City of Fraser

AGENDA

CITY OF FRASER PLANNING COMMISSION
MUNICIPAL BUILDING ~ 33000 GARFIELD ~ PHONE: 586-293-3100
WEDNESDAY, SEPTEMBER 7, 2022 at 7:00pm

DRAFT PLANNING COMMISSION MINUTES CITY OF FRASER 33000 GARFIELD, FRASER, MI 48026 JUNE 1, 2022 7:00 P.M.

SITE PLAN

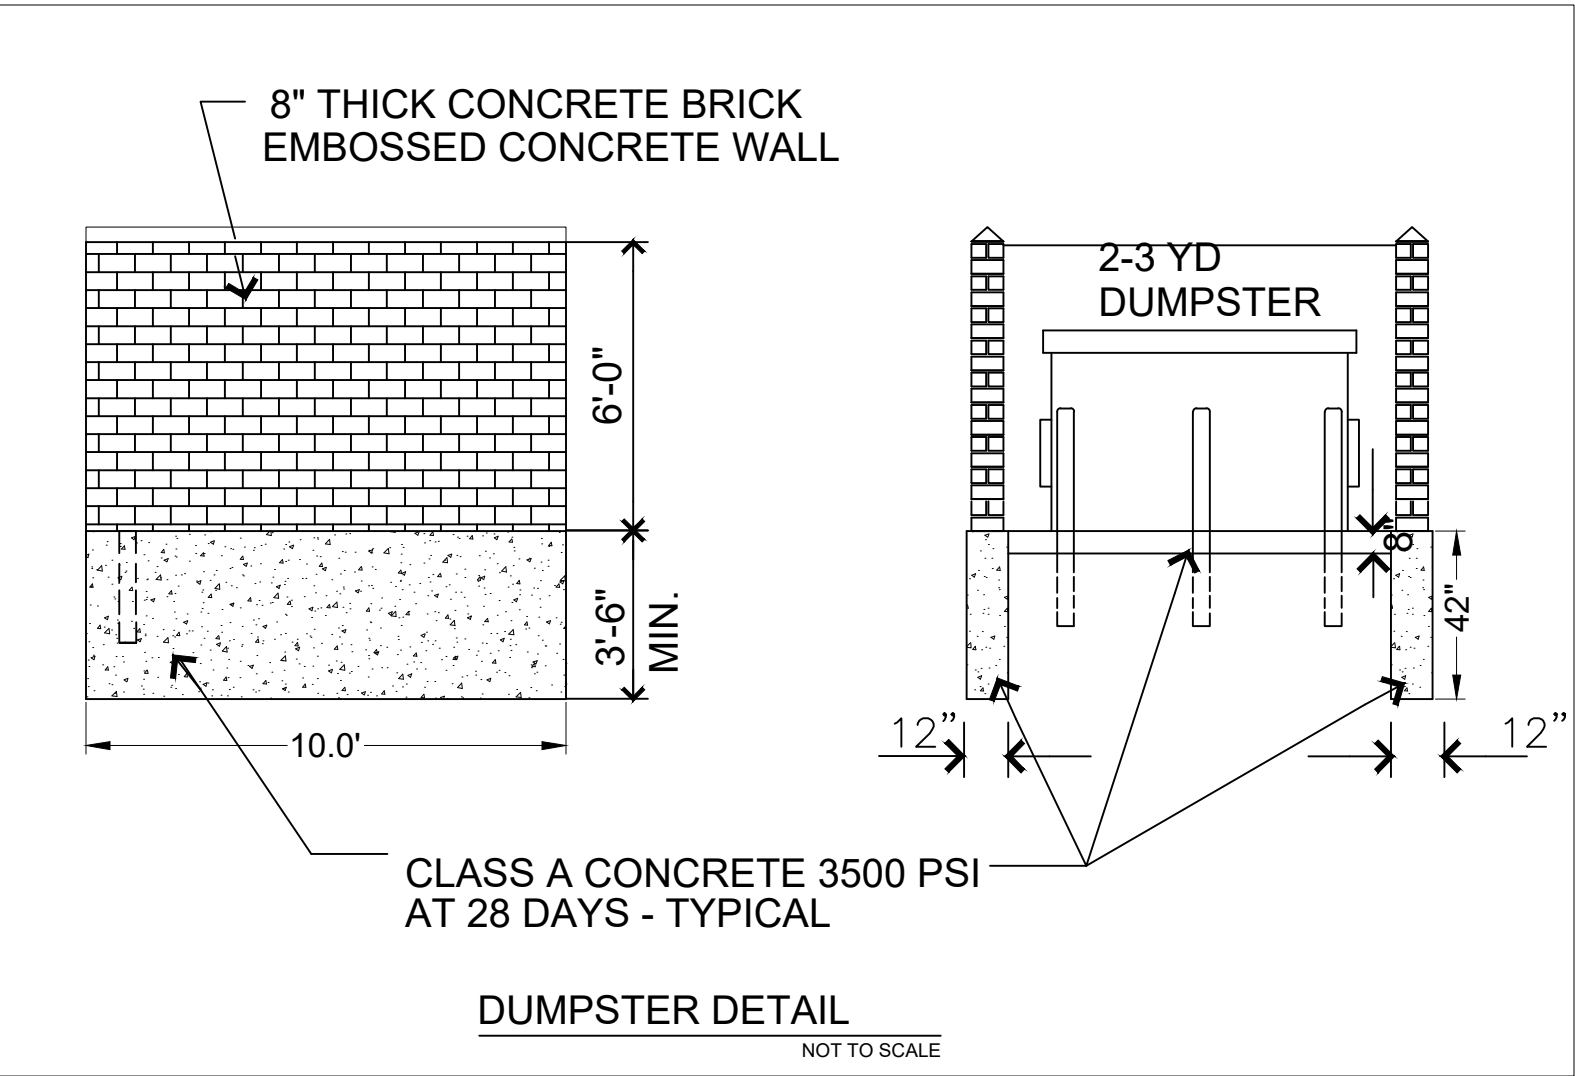
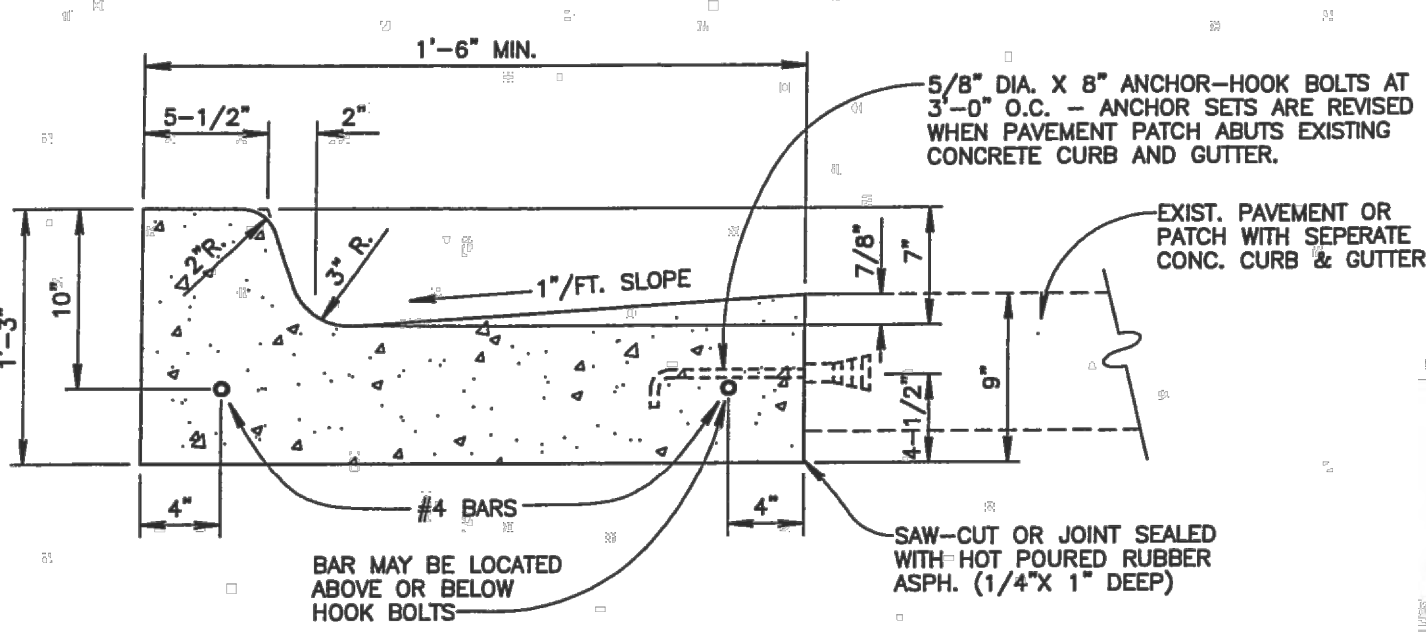
The plans show all the stores having three-dimensional signs along their sign band. Section 32-85(k) of the Ordinance states that “except for freestanding signs, all signs shall be displayed flat against the wall of the building or parallel to the wall of the building. Such signs shall not project beyond or overhang the wall or any permanent architectural feature by more than one (1) foot”. Therefore, the applicant should be sure that the proposed signage projects out from the building by no more than one foot.

The applicant proposes to add parking islands with landscaping on the north parcel. This helps the property, which in its present state does not comply with Ordinance requirements, to be brought closer to compliance and will improve the appearance of the property. However, details of this landscaping were not provided.

1. *The applicant should provide details regarding the proposed landscaping for review.*

2. *We recommend that the applicant provide shared access agreements to ensure that all parking on the site is accessible currently and in the case of a change in ownership.*

Section 32-44 requires Planning Commission approval for the erection of a fence in a commercial district. The [Fence Ordinance](#) prohibits fences between the front building line and the front property line.

3. The site plan must be revised to remove the 6-foot high masonry screen wall and, if desired, to replace it with an Ordinance-compliant solution.

- 1. The applicant provide details regarding the proposed landscaping for review.*
- 2. We recommend that the applicant provide shared access agreements to ensure that all parking on the site is accessible currently and in the case of a change in ownership.*
- 3. The site plan must be revised to remove the 6-foot high masonry screen wall and, if desired, to replace it with an Ordinance-compliant solution.*

ARCHITECTURAL SITE PLAN

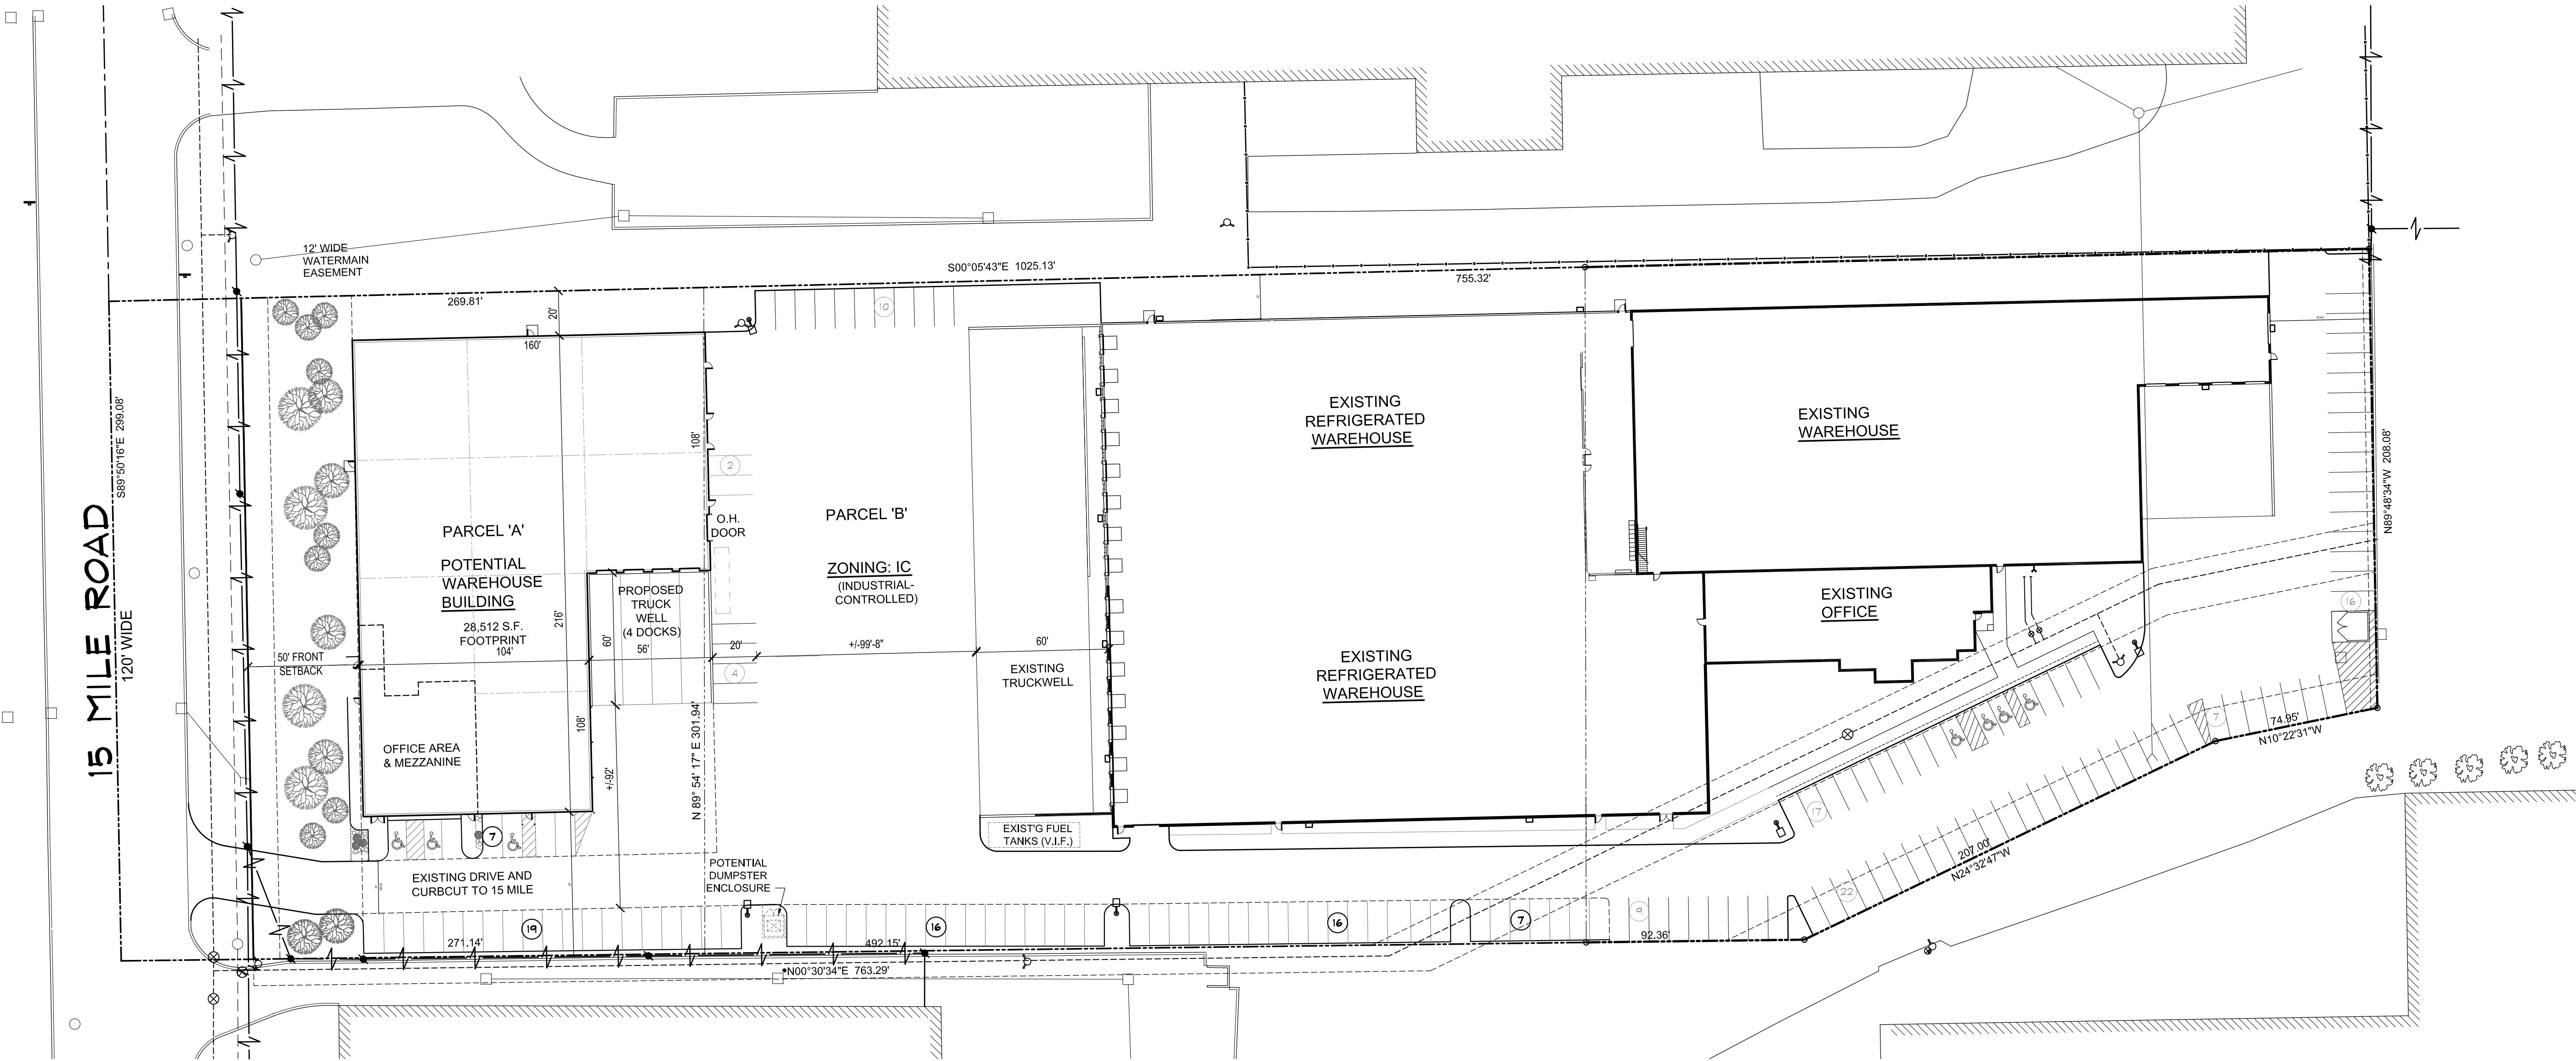
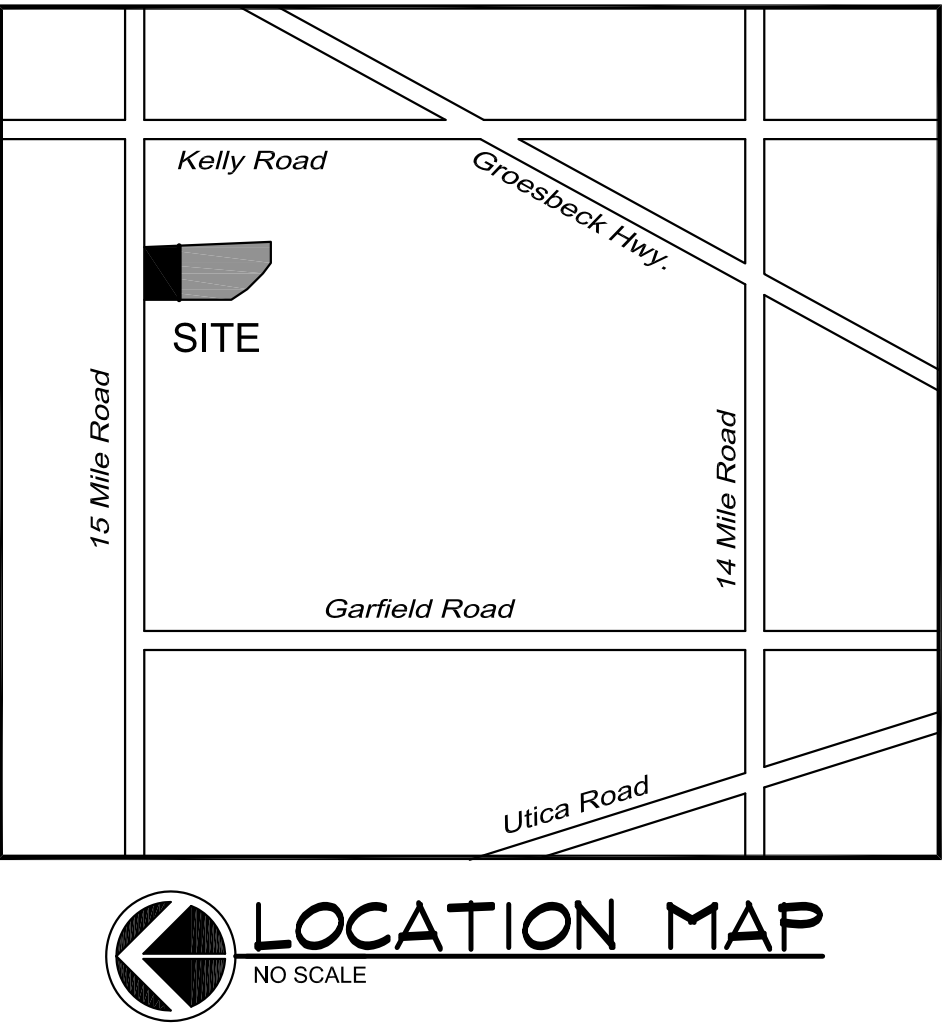
We recommend that, to address the lack of a required setback, the applicant pursue a lot line adjustment to move the rear property line approximately 20' to the south.

The proposed building is also adjacent to a shared truck maneuvering area, parking spaces and loading space that serve the new building but are located on the adjacent parcel under common ownership.

Operationally, there are no apparent concerns with this but we recommend that appropriate easements are recorded to ensure the parcels could function independently if they are no longer under common ownership.

5. *The applicant must submit details of the proposed site lighting plan to ensure compliance with Zoning Ordinance requirements.*

PROPOSED OUTDOOR PATIO

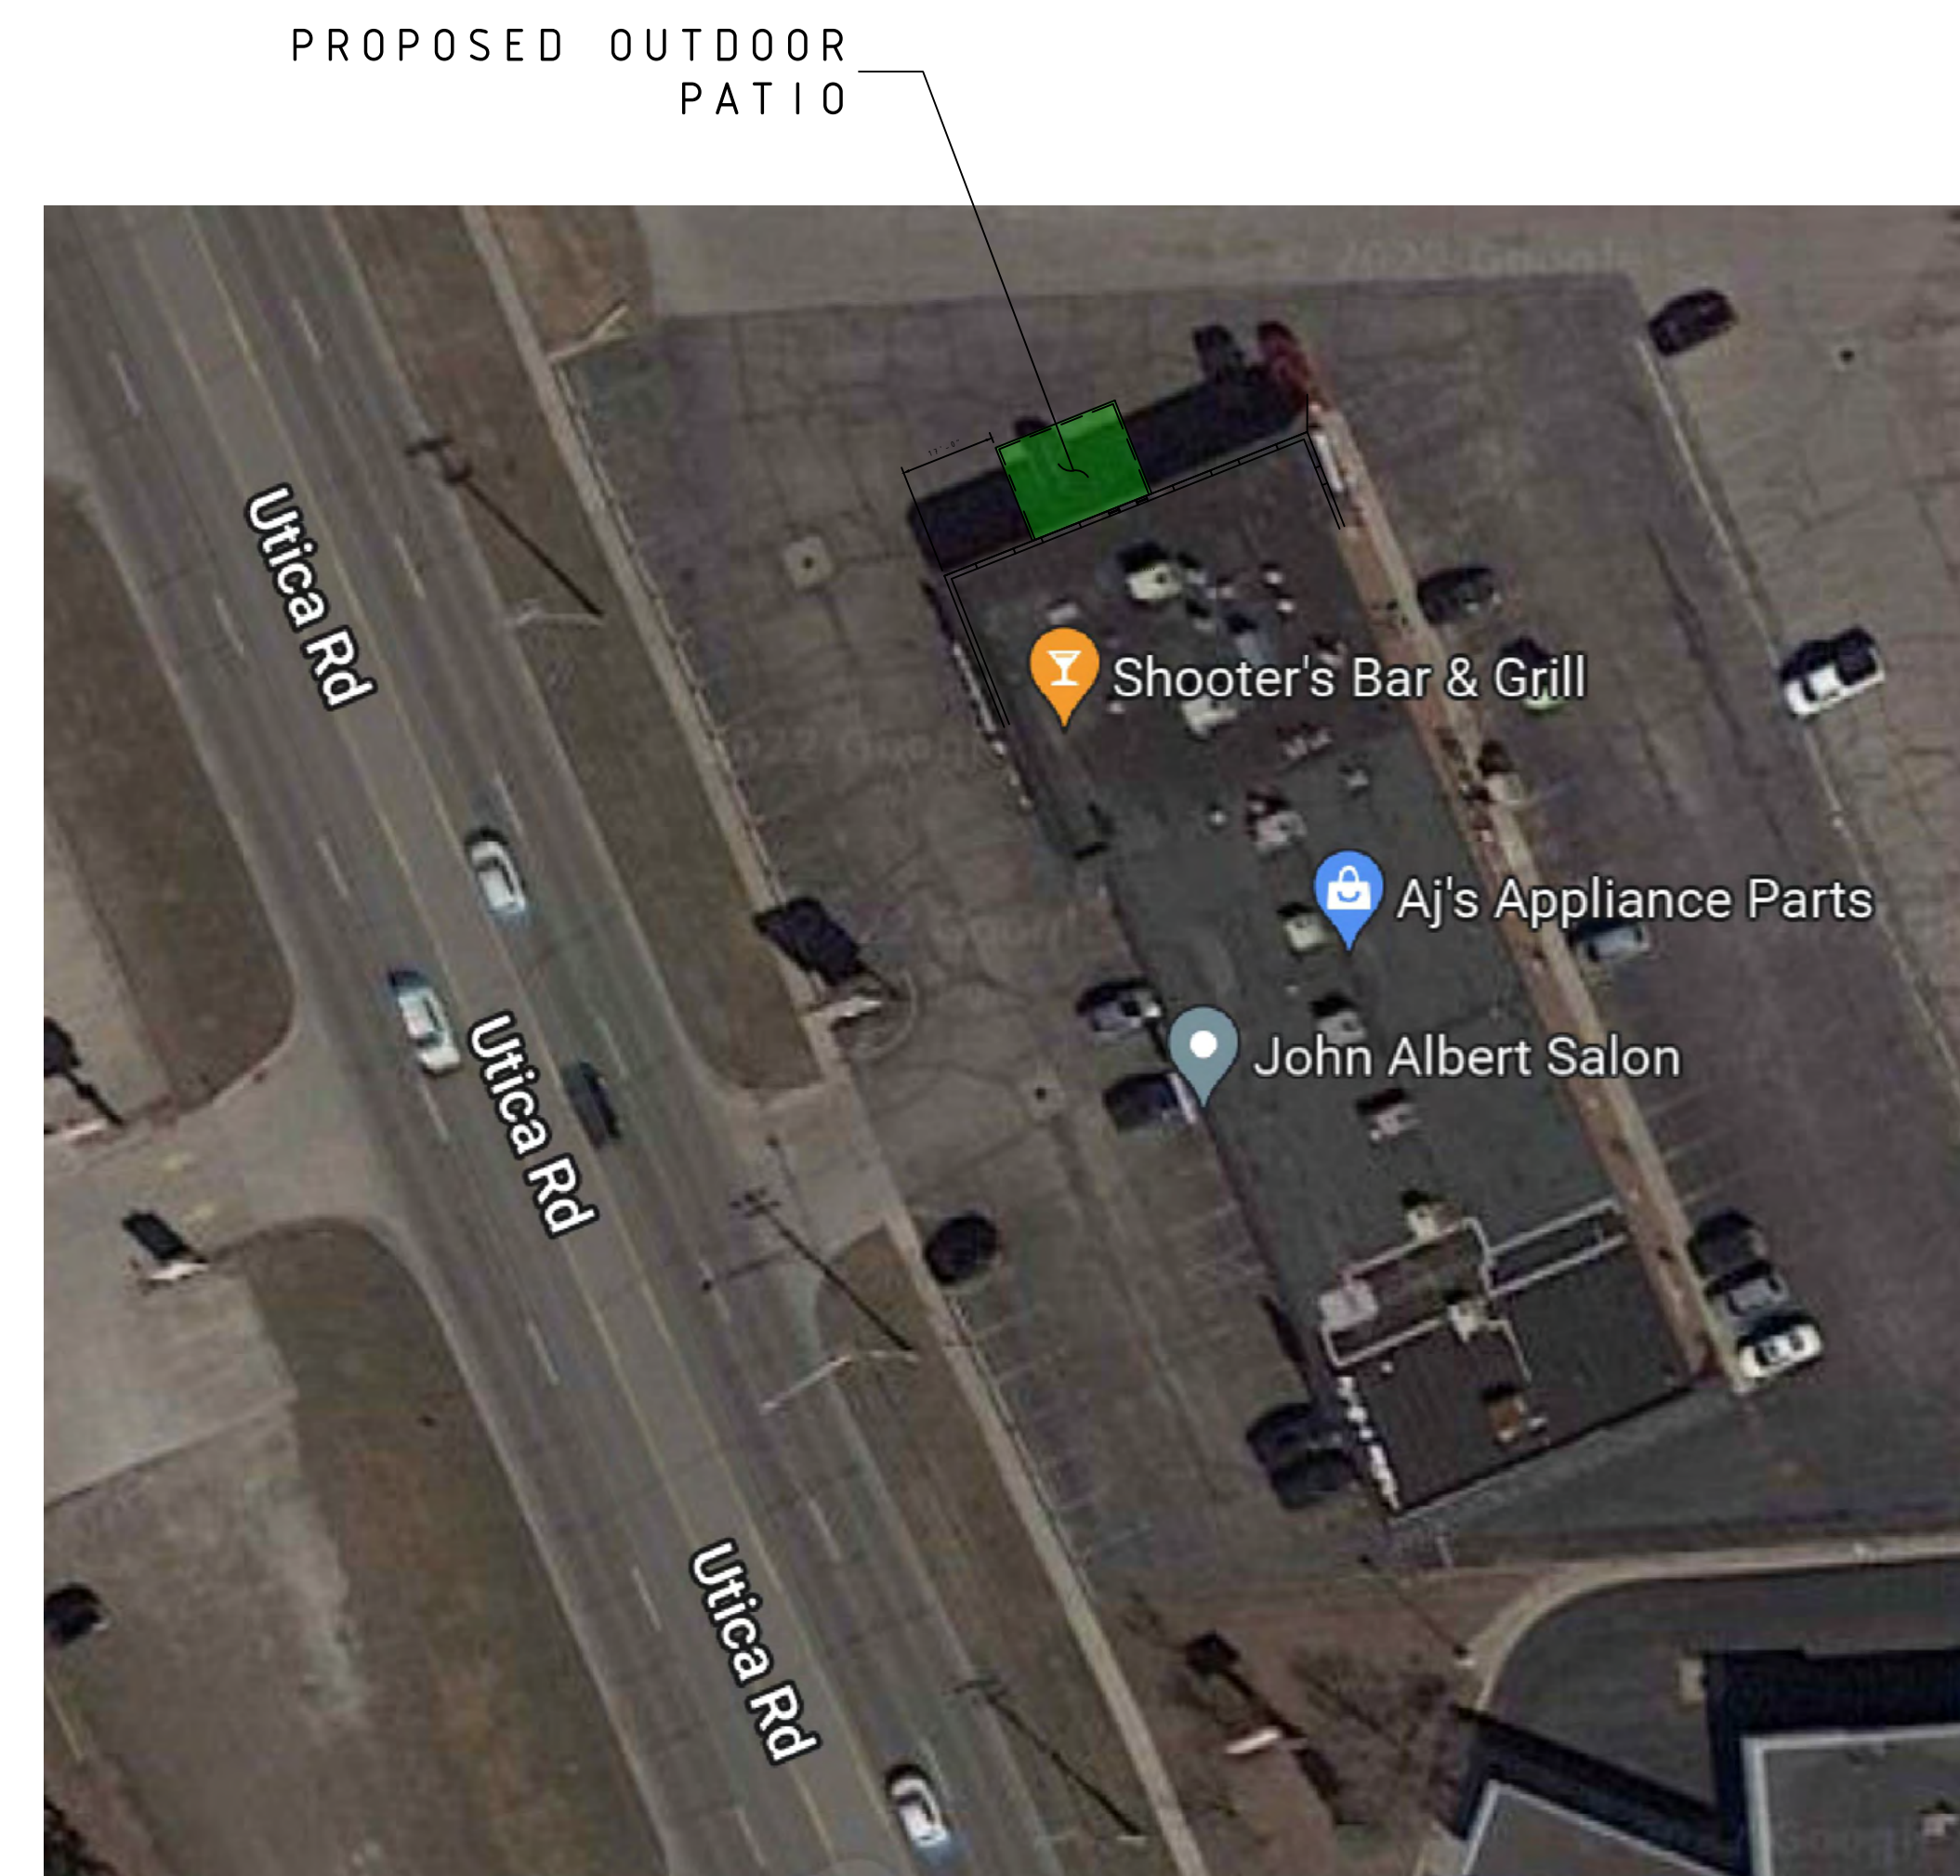
Commissioner Meyer asked about the egress exit door, and if the gate is planning to have a lock. The architect explained that there will not be a lock on the gate, and it is required by the liquor commission to have the gate. It was also asked about the planters and what they

would look like. The architect noted that the planters will be out all year round and will be an elongated planter.

Chair Warunek asked about how many seats they plan to have on the patio, which would be determined by the Fire Marshal. The owner made a comment they are going to be doing 4-person tables.

They will need to include a photometric plan, handicap parking spot locations and number as well. Windows in the front will be replaced, the glass has been ordered. Comments were made regarding the dumpster location and how it can be upgraded to help the parking calculations.

Addition of a bike rack, showing of sign repair, photometric plan, hours of operation for the patio, max occupancy, configuration of planters to be added, tables and chairs design, dumpster enclosure and location, and addition of ADA spaces.

Motion by Farina supported by Perry to postpone the site plan approval, SPR 22-01 34360 Utica Road Shooter's Proposed Outdoor Patio, until the September 7, 2022 meeting, with a revised plan submitted, including the recommendations from the board.
